Errata for “On-The-Go and Embedded Host Supplement to the USB Revision 2.0 Specification, Revision 2.0, May 8, 2009”, as of May 25, 2010

Changes to section 7.1, Figure 7-2:

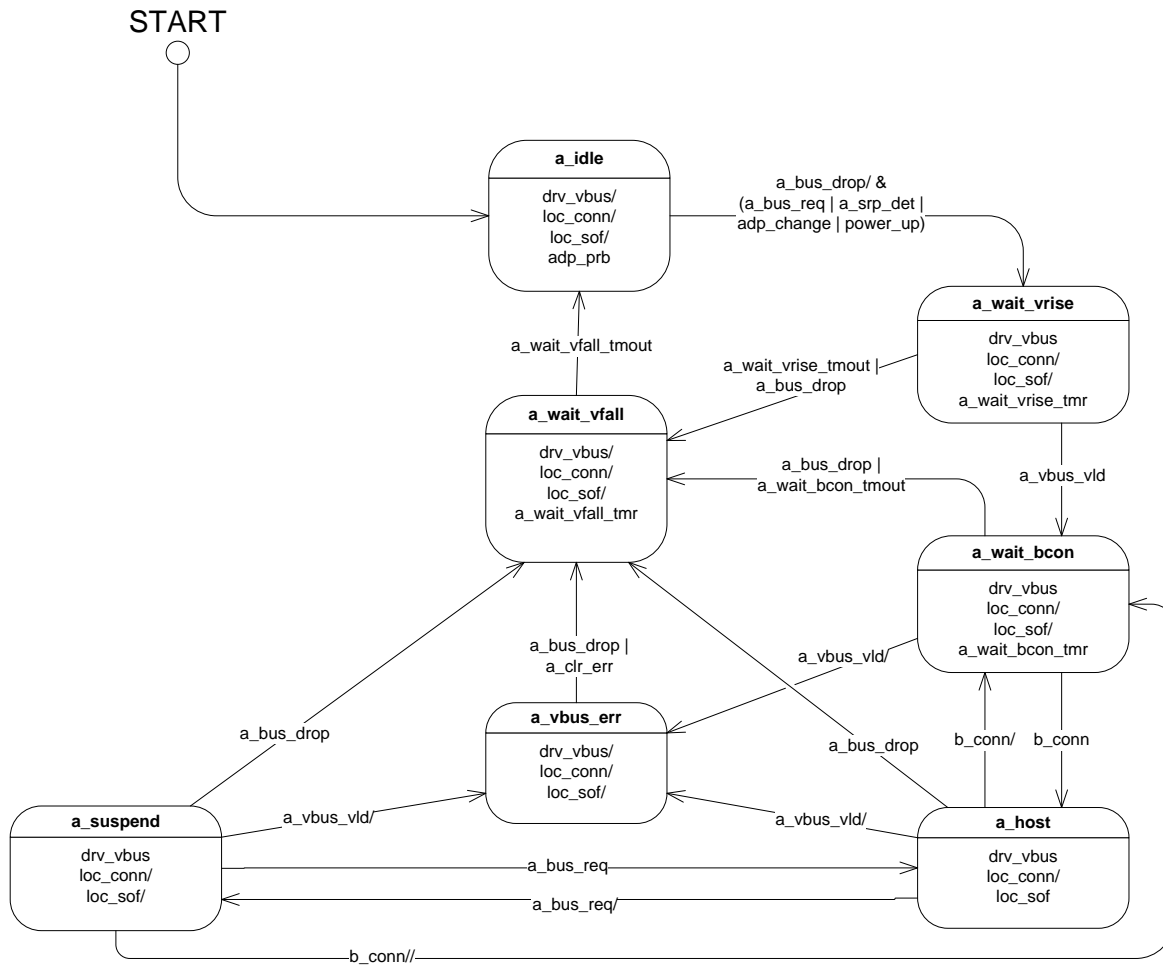
Embedded Host state diagram uses ID/:

Background: The state diagram includes a reference to ID/ which is not applicable for Embedded Hosts.

Replace Figure 7-2 with the following:

Changes to Figure A-1:

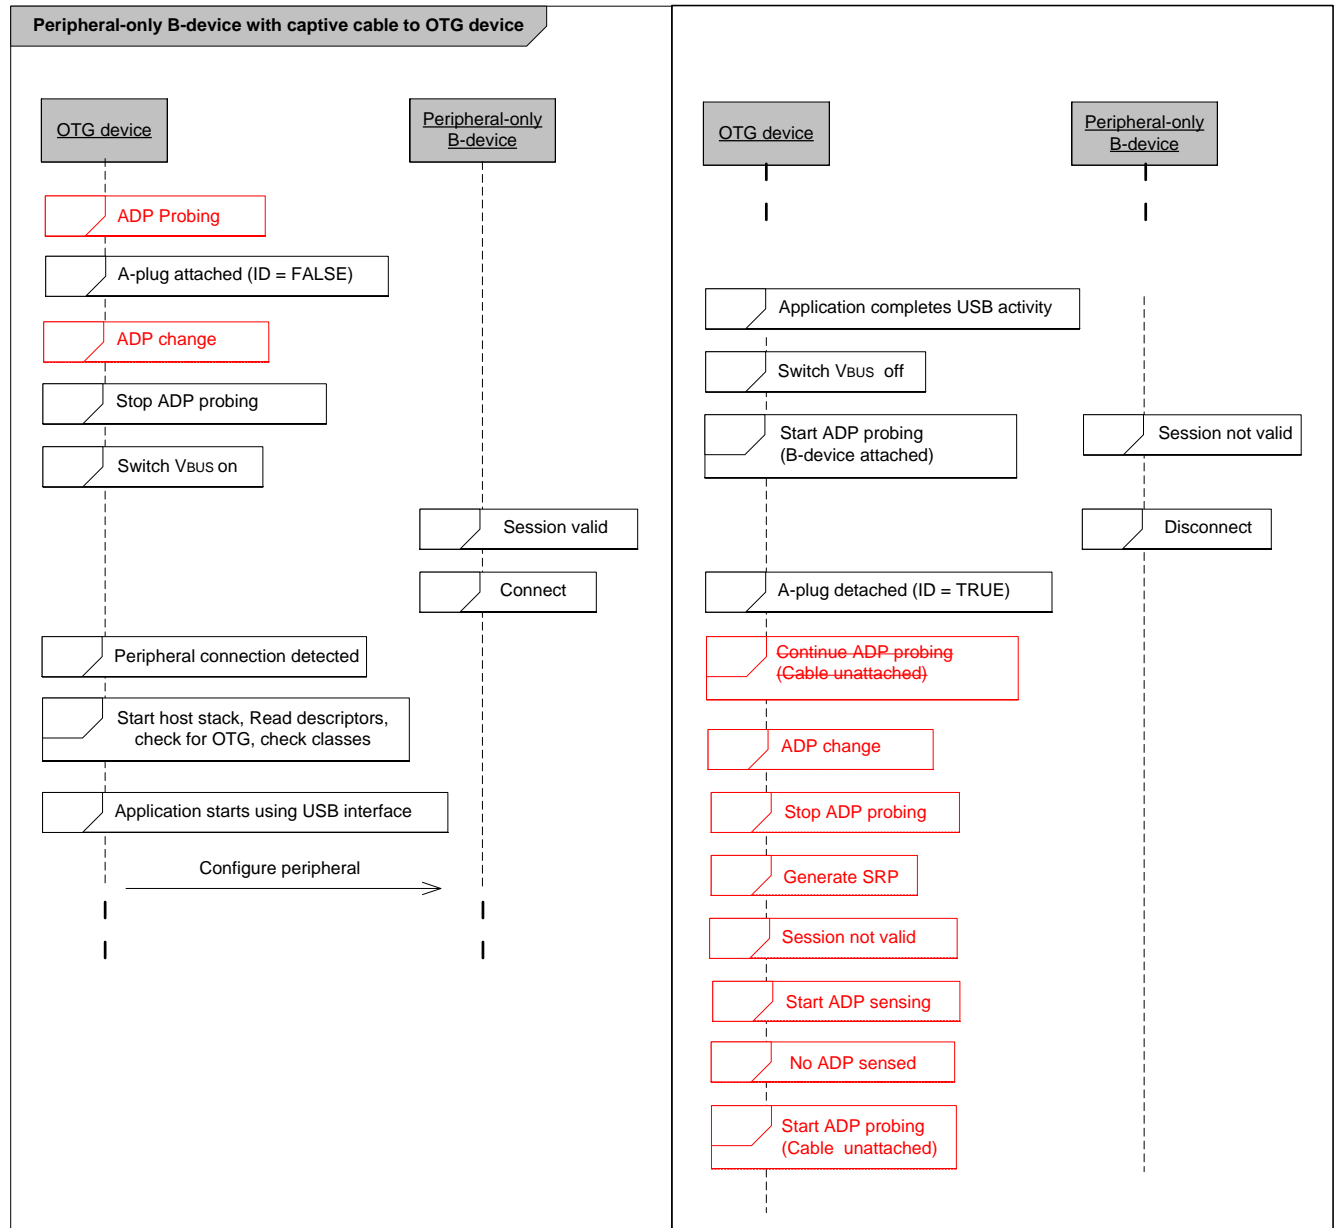
Background: Figures A-1, A-2, A-3, A-4, A-5, A-6, A-8, A-9, A-10, need to be updated to reflect current expected ADP behavior. There are 2 changes which have been applied to several of the diagrams:

Initial ADP State: Add box showing initial ADP state: A-1, A-2, A-3, A-4, A-5, A-6, A-8, A-9 and A-10

A-plug Ignore: Remove incorrect responses to A-plug attach for ADP devices: A-3, A-5 and A-8.

Edit Figure A-1 as shown in the diagram below. This adds Initial ADP state, adds missing ADP change after A-plug attached and adds the correct behavior when the A-plug is detached.
